Enclosed is the signed and completed joint NPS/COE permit (USACOE permit no. 199301691), and Statement of Findings for same.

SUPPLEMENTAL ENVIRONMENTAL ASSESSMENT

Project Description: Work includes excavating and stockpiling ± 10 million cubic yards of material in order to restore 6,250 acres of wetlands within the Hole-in-the-Donut. In addition, $\pm 240,000$ cubic yards of permanent fill will be placed over ± 10 acres to construct 3 overlook mounds, each approximately 25 feet high, with parking spaces for 30 automobiles. Temporary roads required to facilitate the excavation and removal of material will be restored to the original condition when no longer needed. The project is as shown and described in attached plans numbered 199301691(IP-OC) in 6 sheets, dated December 1992.

DISPOSAL AREA PLAN

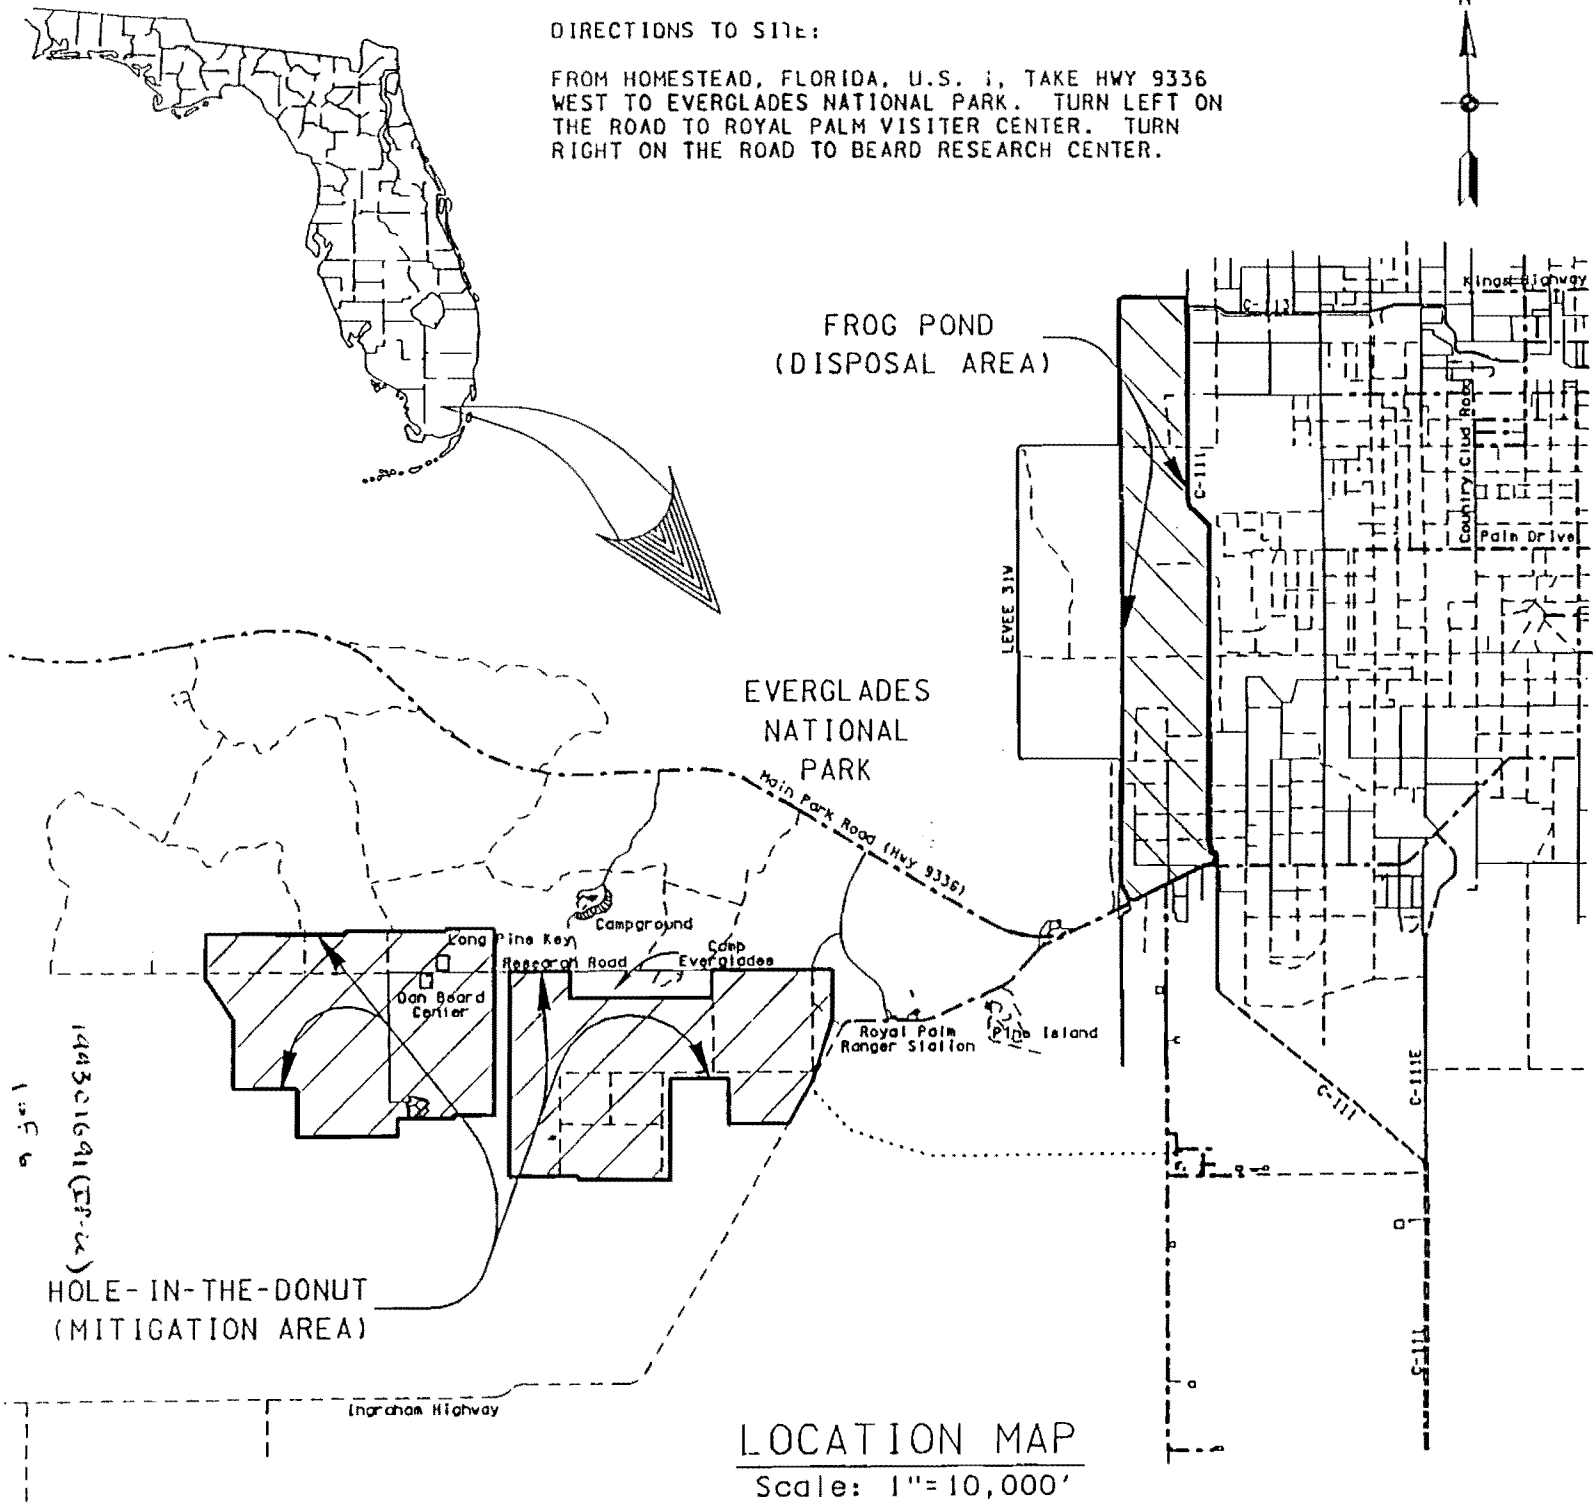
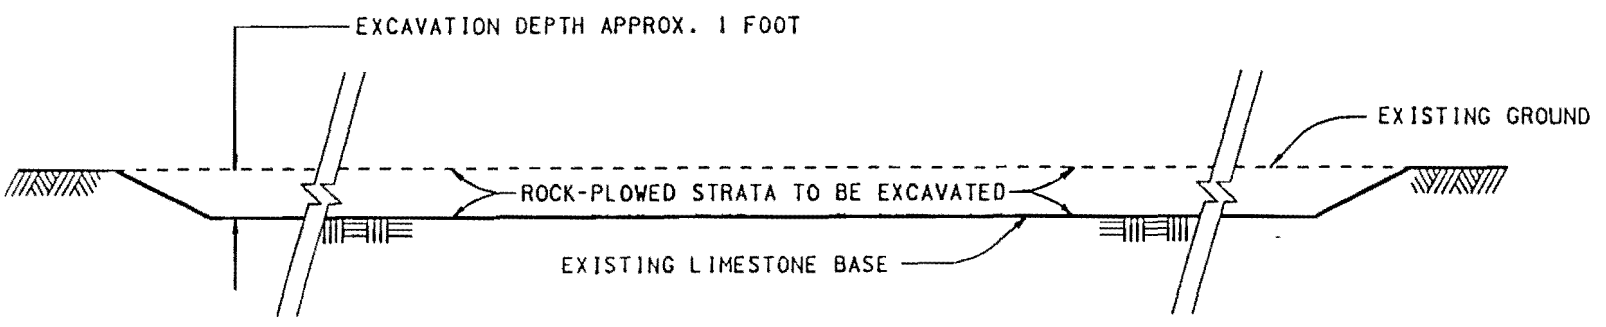
15. ~~Off-site Disposal of the excavated materials shall occur in upland areas within the Frog Pond as indicated on Sheet 3 of~~ on-site in former wetland areas and borrow pits, as indicated on the attached permit drawings, within the proximal agricultural areas east of the C-111 canal, or within other upland areas in coordination with the U.S. Army Corps of Engineers Central and South Florida Project within the C-111 Basin. The proposed locations of specific spoil sites must be submitted to the Bureau of Submerged Lands and Environmental Resources Office of Intergovernmental Programs, Tallahassee, for review and approval prior to disposal.

OVER-LOOK PLAN,
PROFILE AND X-SECTION

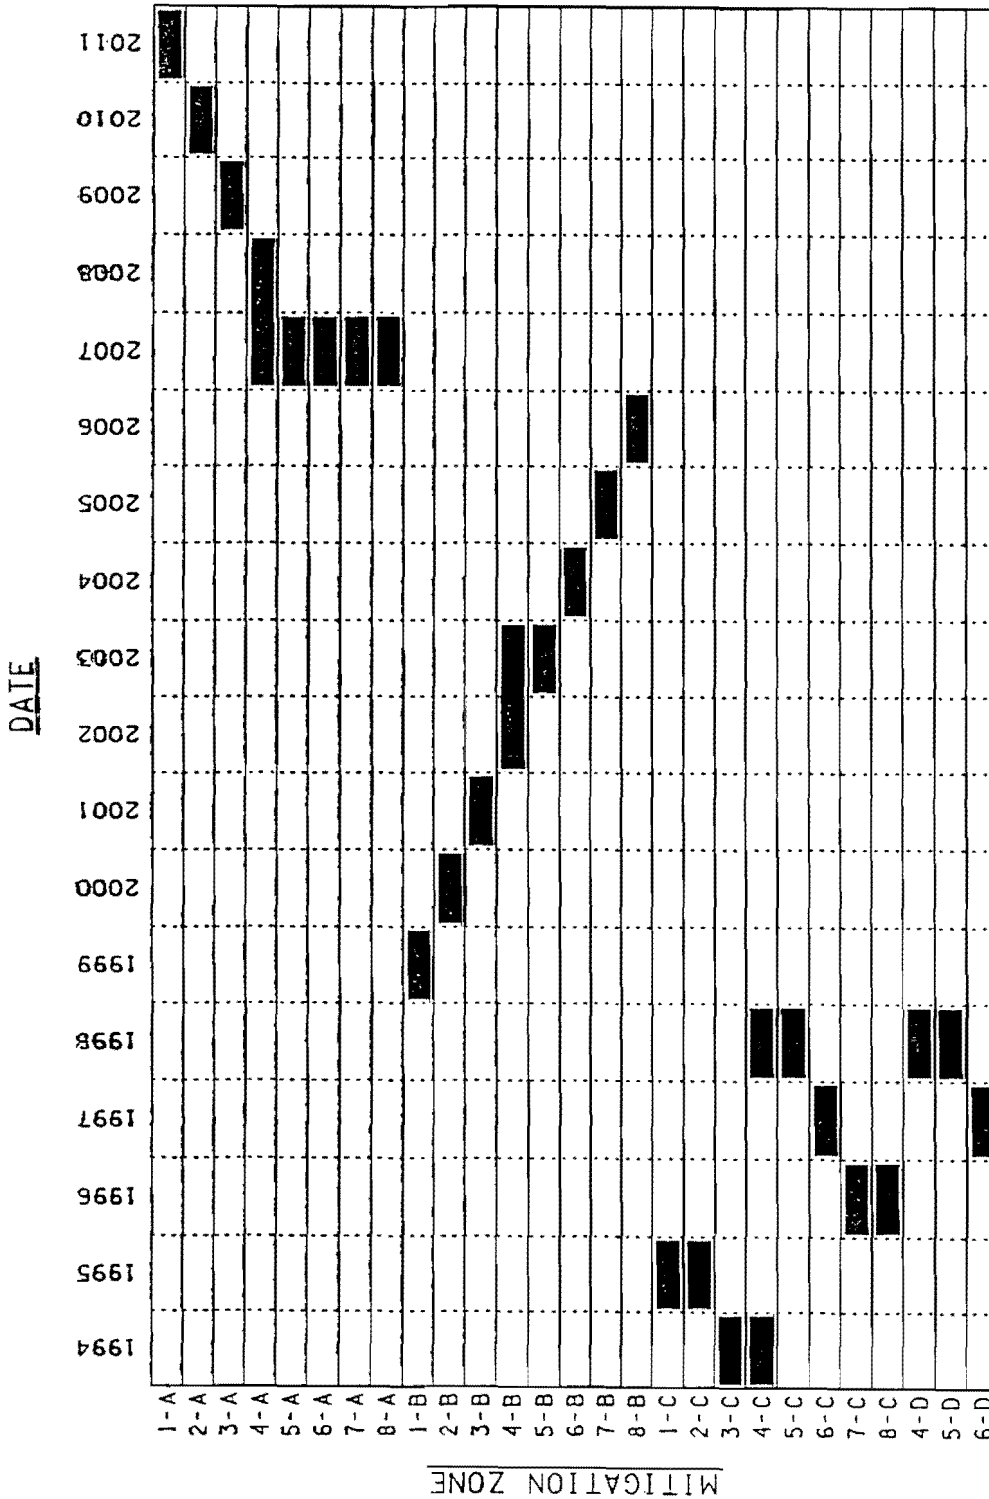
iii. Only the overlook mounds numbered 1, 5, and 7 on the project plans will be constructed.

(3) The ENP agrees to delete the 3 overlook mounds specified by the FWS and, additionally, will also delete mound number 6.
